Application of Minnesota Energy Resources Corporation for a Route Permit for the Rochester Natural Gas Pipeline Project in Olmsted County | GP-15-858

Re: Rochester Public Utilities Commissions Docket #G-011/GP-15-858

I am writing on the behalf of myself and other neighbors who will be affected by the proposed Rochester Natural Gas Pipeline Project in Olmsted County. The Commission's docket number is 15-858.

RESIDENCES, COMMERCIAL AND OUT BUILDINGS AND MINNESOTA POLLUTION CONTROL AGENCY LISTINGS
 ROCHESTER NATURAL GAS PIPELINE
 FIGURE 10 (PAGE 3 OF 10)

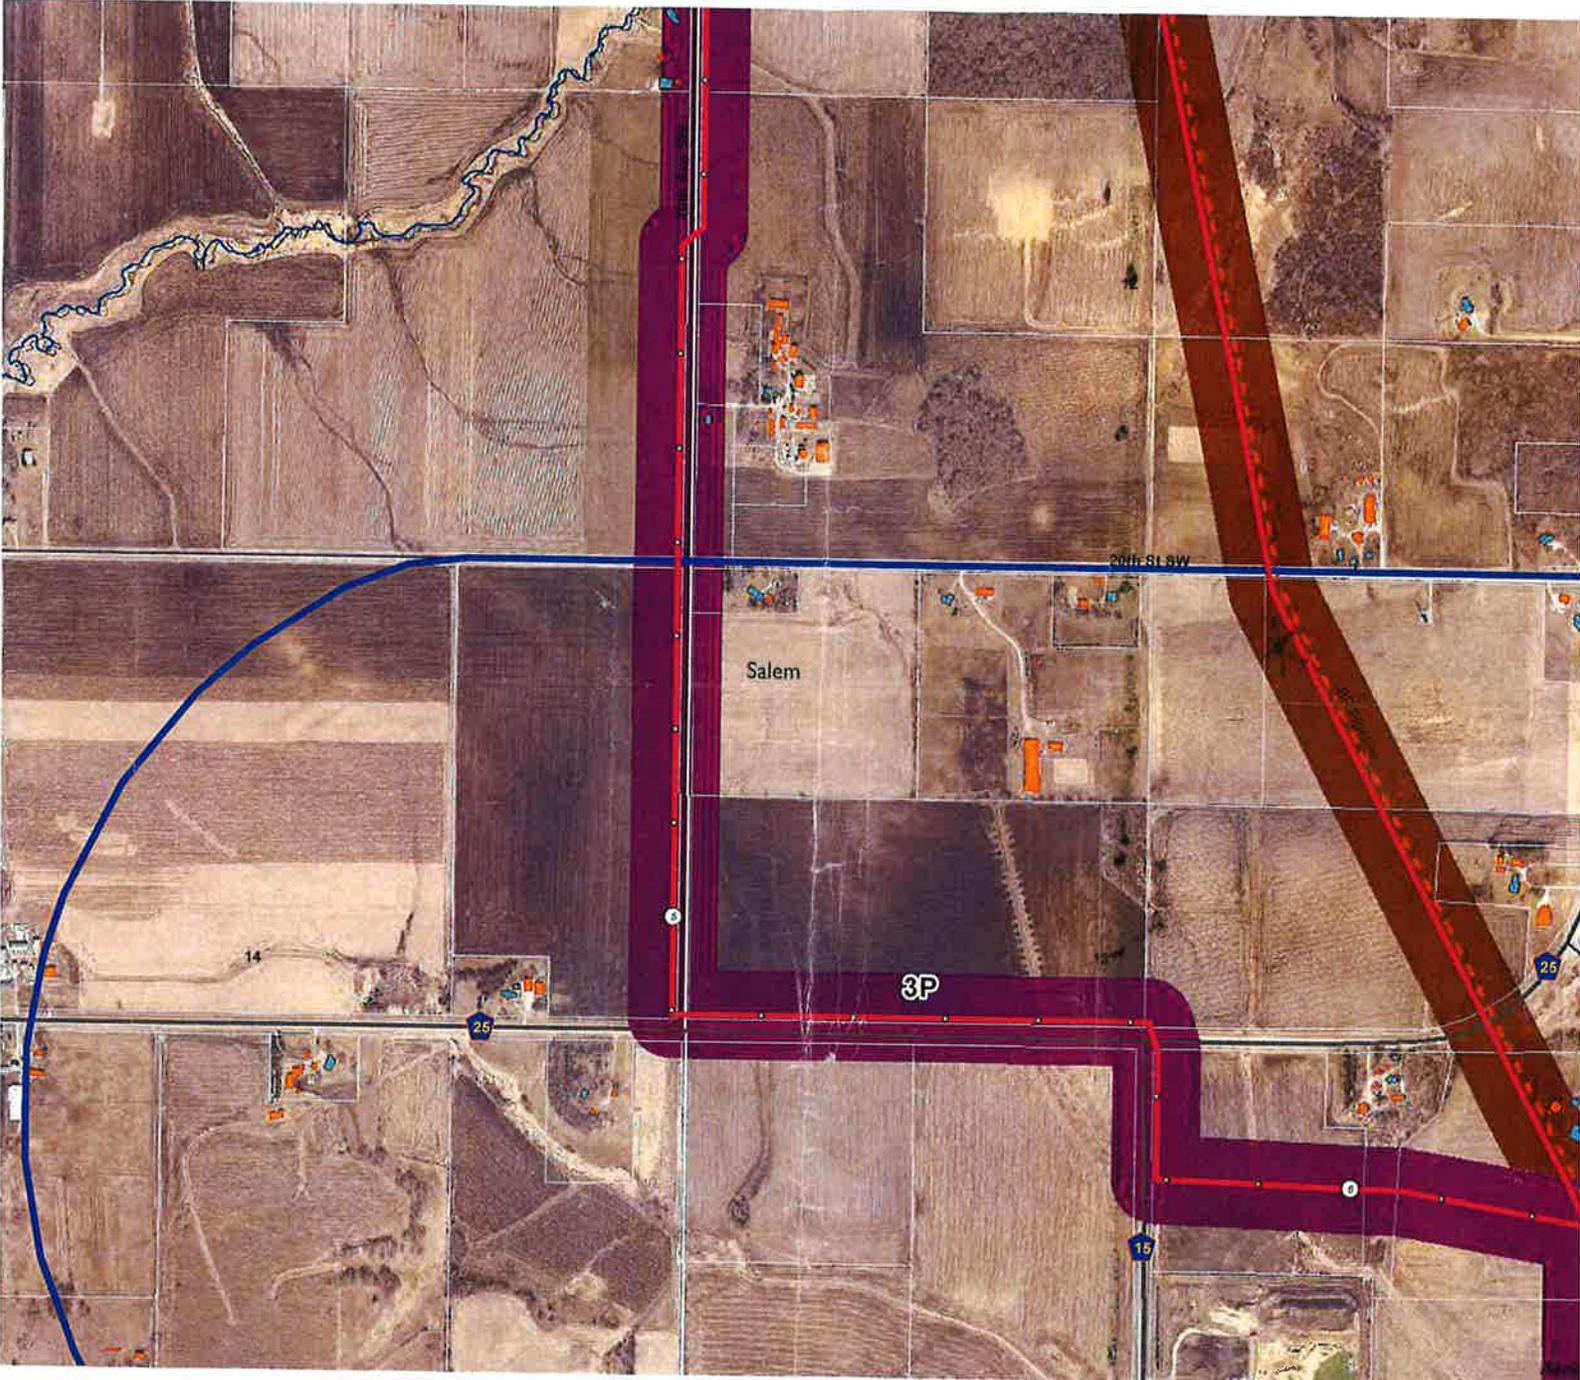
My neighbors and I are not opposed to the pipeline but we would like the pipeline to avoid our home sites. For example, I live at 901 70th Ave SW, Byron, 55920. The pipeline travels on the east side of 70th Ave and then crosses the road (to the west side) and then travels another half mile to pass my residency. It then crosses over to the east side again. We were hoping for the pipeline to stay on the east side for as long as it could. We understand that there will be spots were it might be unpassable, but once pass that part, can they avoid residencies.

I included a map of our section. I put a star by my house and drew a black marked line where we would hope the pipeline could travel. I think we would all like the pipeline to travel next to another previous pipeline but that might not be an option.

RESIDENCES, COMMERCIAL AND OUT BUILDINGS AND MINNESOTA POLLUTION CONTROL AGENCY LISTINGS
 ROCHESTER NATURAL GAS PIPELINE
 FIGURE 10 (PAGE 3 OF 10)

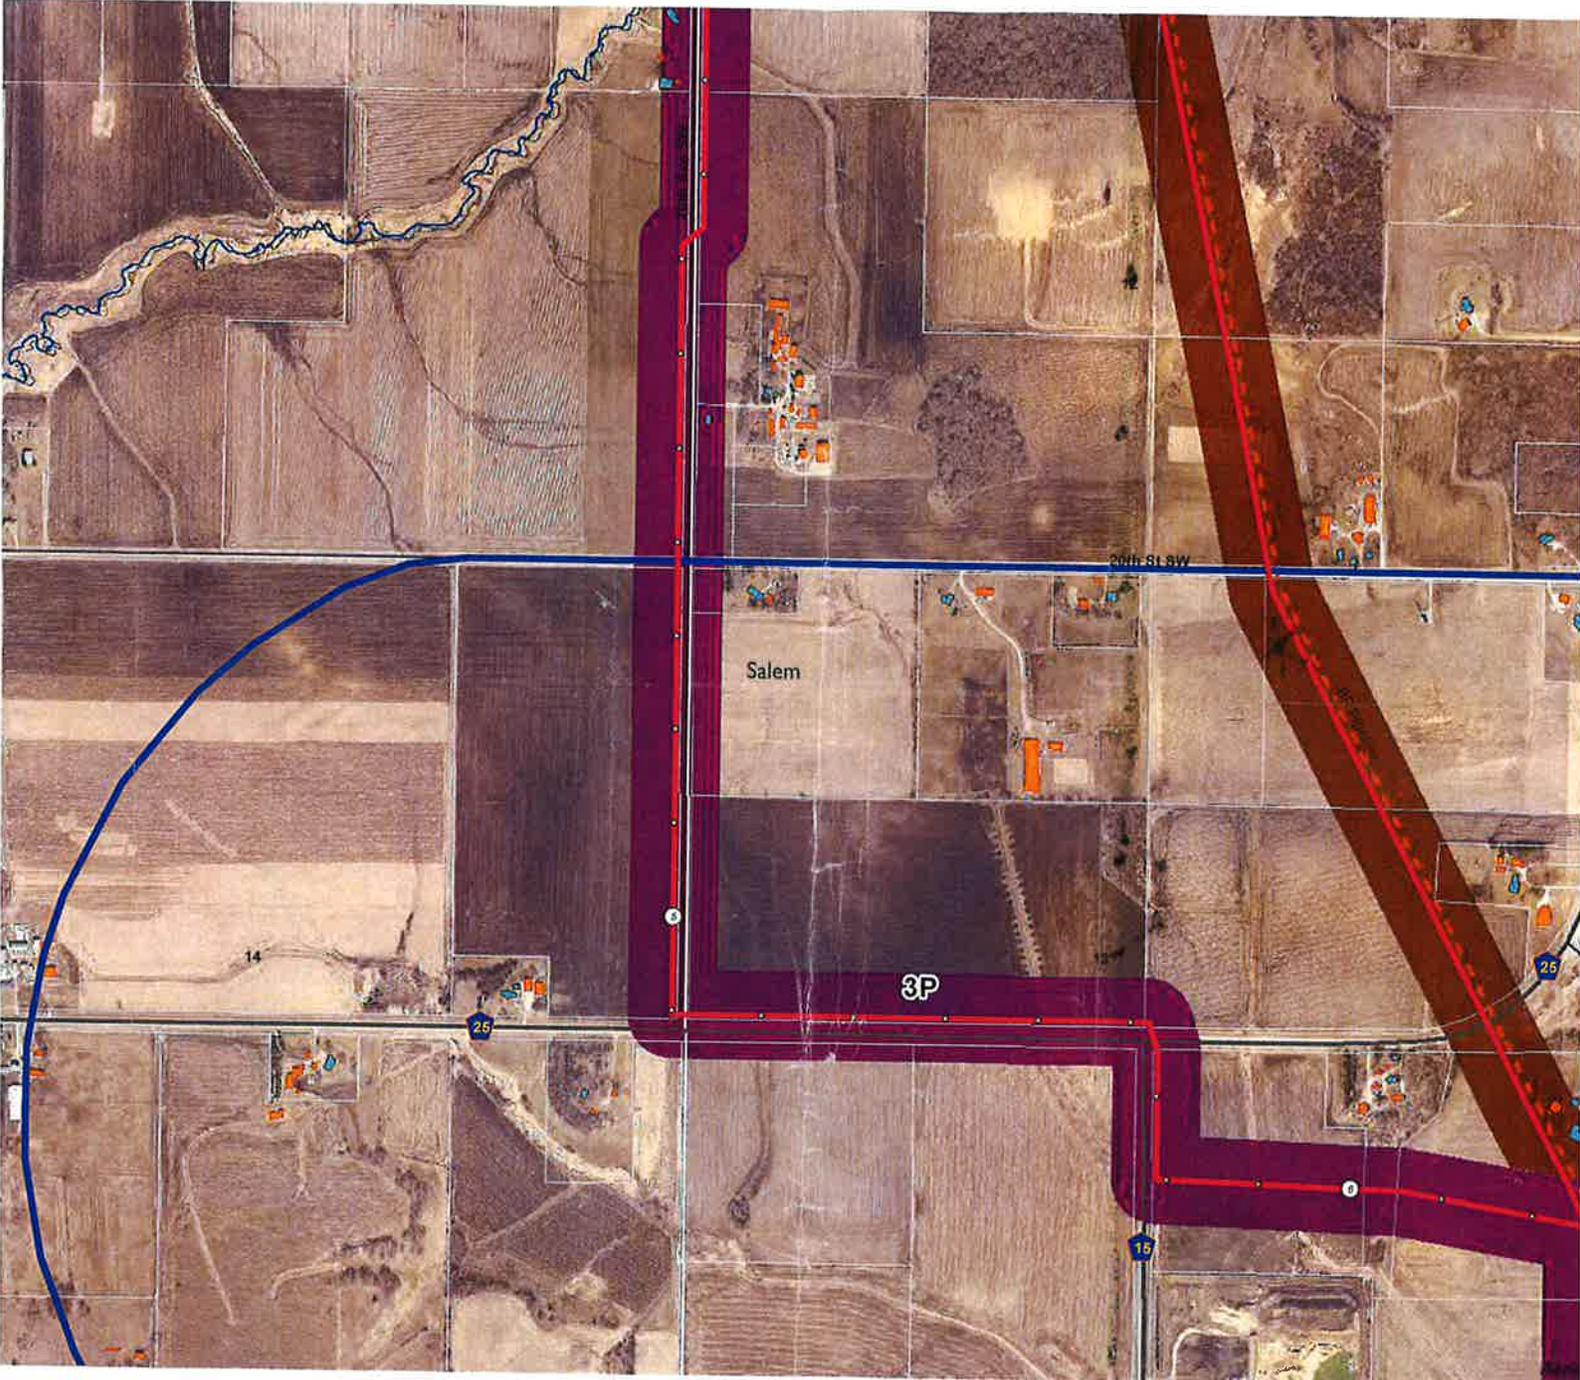
My neighbors and I are not opposed to the pipeline but we would like the pipeline to avoid our home sites. For example, I live at 901 70th Ave SW, Byron, 55920. The pipeline travels on the east side of 70th Ave and then crosses the road (to the west side) and then travels another half mile to pass my residency. It then crosses over to the east side again. We were hoping for the pipeline to stay on the east side for as long as it could. We understand that there will be spots were it might be unpassable, but once pass that part, can they avoid residencies.

I included a map of our section. I put a star by my house and drew a black marked line where we would hope the pipeline could travel. I think we would all like the pipeline to travel next to another previous pipeline but that might not be an option.
